MODIFICATION RECOMMENDED - CORRECTS MANUFACTURING OR DESIGN DEFECTS

6681A-08

SERVICE NOTE

6681A DC POWER SUPPLY

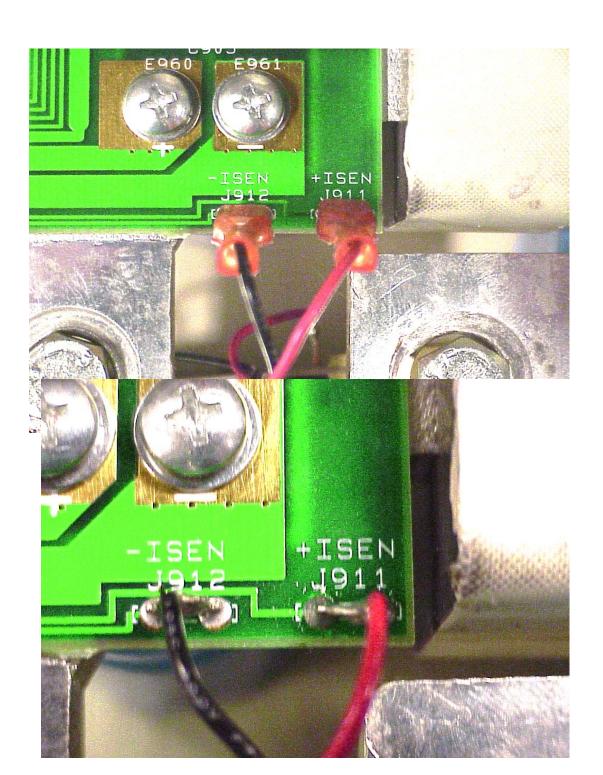
The first picture below shows how the Shunt "R900" is connected using the term-crimp connectors. The Shunt "R900" is connected to (-ISEN J912 Black wire) & (+ISEN J911 Red wire).

The second and the third pictures show how the Shunt "R900" is connected when soldered.

The wires should be connected as shown below. The holes in the male connectors should be used to solder the Red and Black wires to the printed circuit assembly marked (–ISEN J912) & (+ISEN J911). Do not mix the Red & Black wires when making this modification. See picture below for details. The pictures shown below show the required modification.

Cut the terminal-crimp connectors off of both wires and discard the connectors. Make this cut as close to the terminal-crimp connector as possible. Carefully strip the wires to approximately 8mm and solder the wires, and avoid burning the wire insulation and the printed circuit board.

- 1. Inspect the solder connections to determine the solder joints are acceptable.
- 2. Inspect the printed circuit board to insure the solder joints are acceptable around (-ISEN J912) & (+ISEN J911) connectors.
- 3. The wires that are now soldered to (-ISEN J912 Black wire) & (+ISEN J911 Red wire) MUST be twisted.
